17-088 Glenilla Road Design Updates for Planning Amendment

17-088 30 Glenilla Road

Revision	Date	Description	Editor	Approved By
-	12.02.2020	PLANNING	HL	EH

This report has been prepared by Ben Adams Architects on behalf of Stuart and Suki Swycher in relation to 30 Glenilla Road, London, NW3 4AN. The report describes changes that have been made to the proposals since planning approval was granted on 10.01.2019.

2.1 Basement

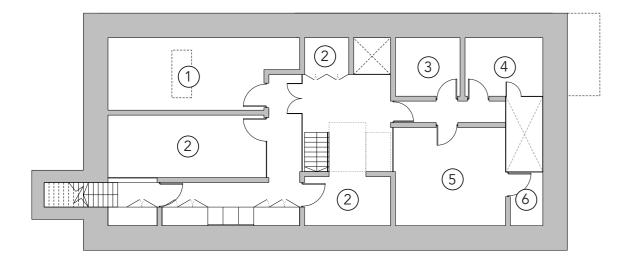
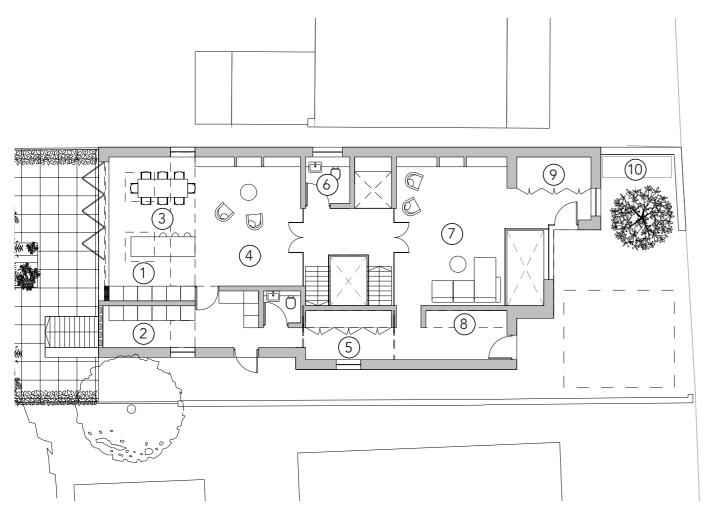
- Longer Stair
- New steam room
- Store now chilled
- Shower added to WC
- Additional accessible shower

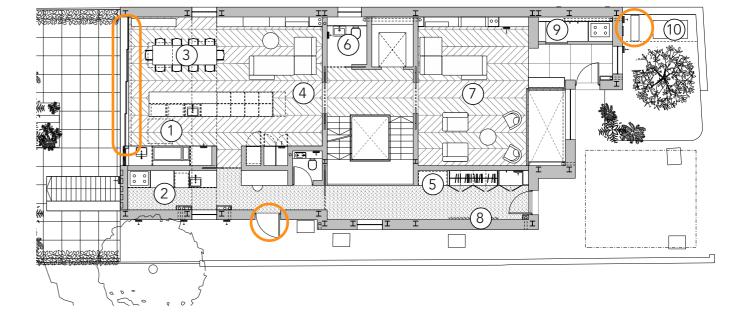
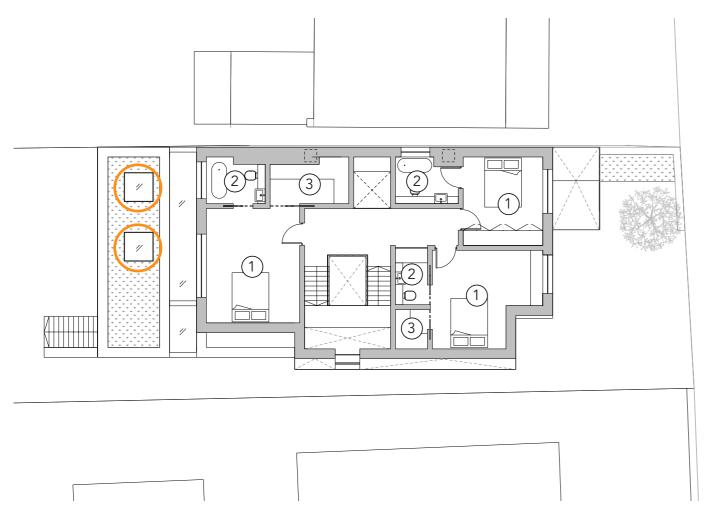
- Air conditioning unit in bin store
- Bi-folding doors changed to sliding doors
- Pantry door changed to glazed door and position updated

2.3

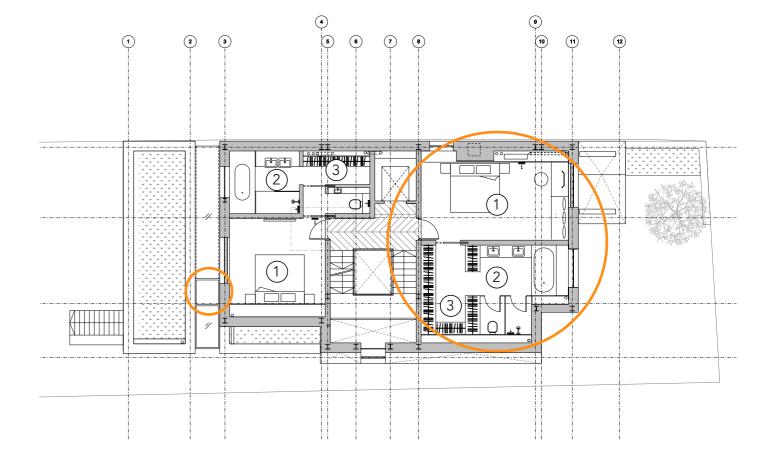
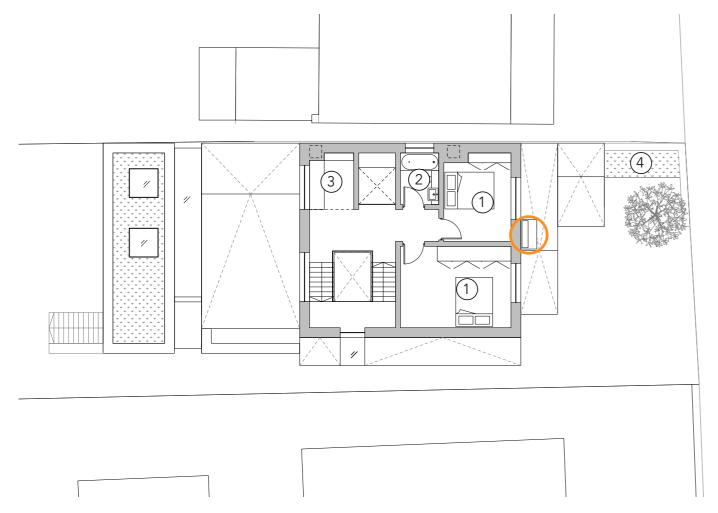
- Rooflights removed
- One bedroom omitted and replaced with larger bedroom and ensuite bathroom / wardrobe
- Solid panel added to kitchen rooflight

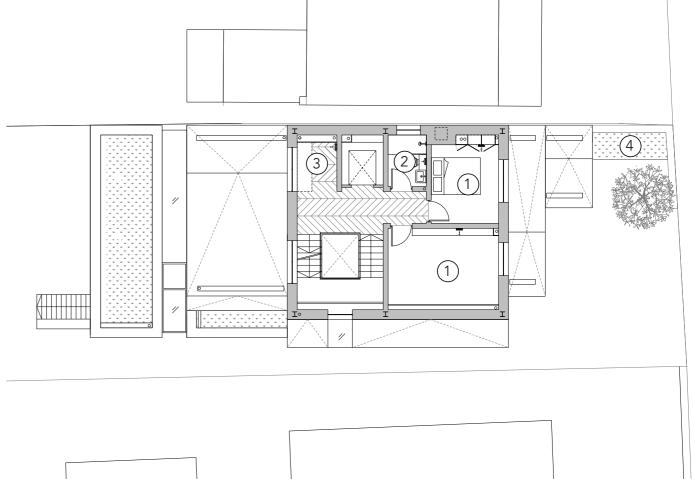
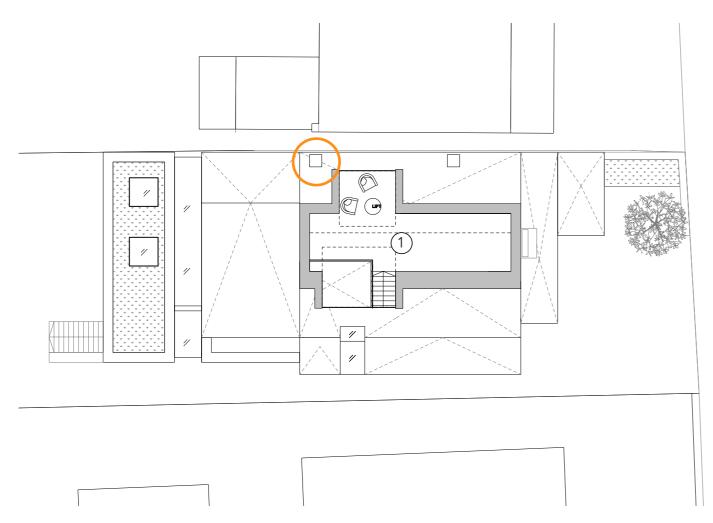
- Air conditioning unit relocated to bin store

2.5 Third Floor

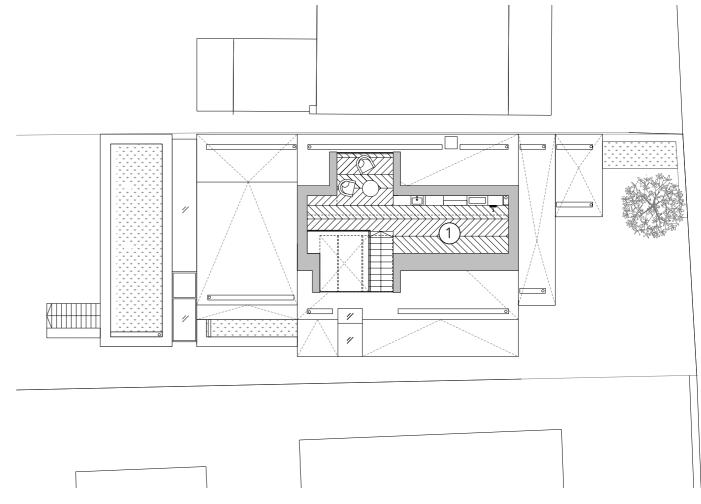
- Chimney removed

3.2

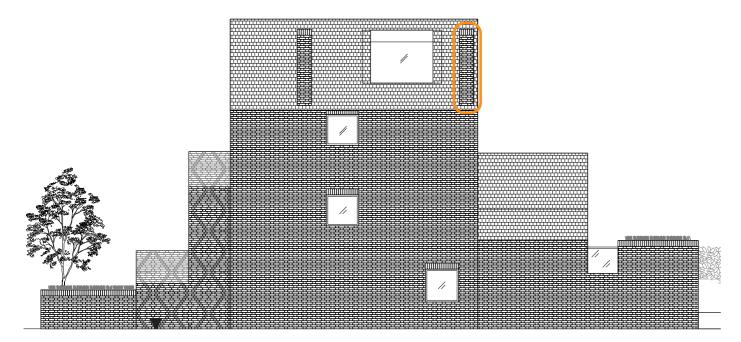
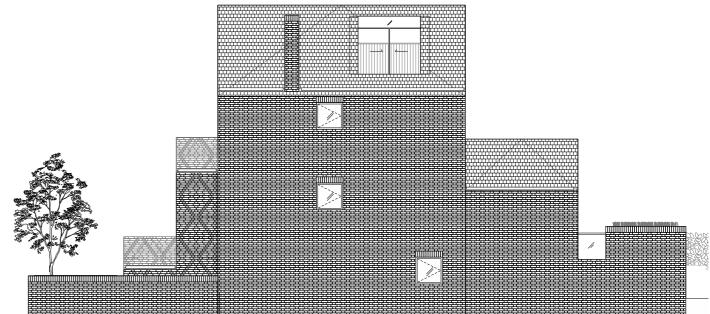
- Chimney removed

3.3 South East

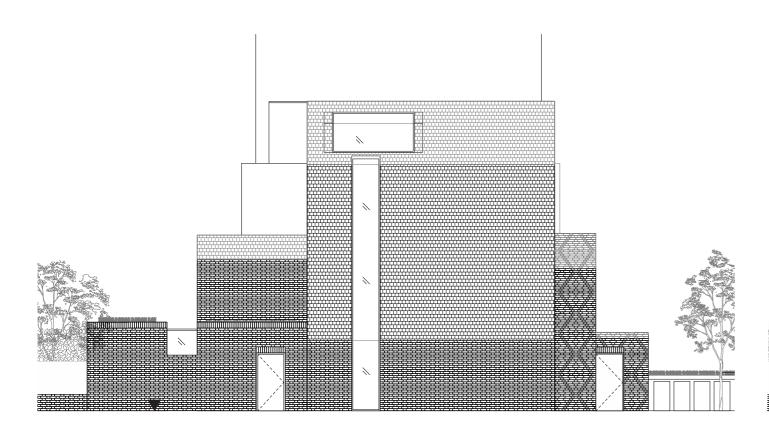
- Pantry door changed to glazed door and position updated
- Window extended
- Linear window adjusted
- Extracts and boiler flue added to elevation
- Chiller unit for chilled store in basement
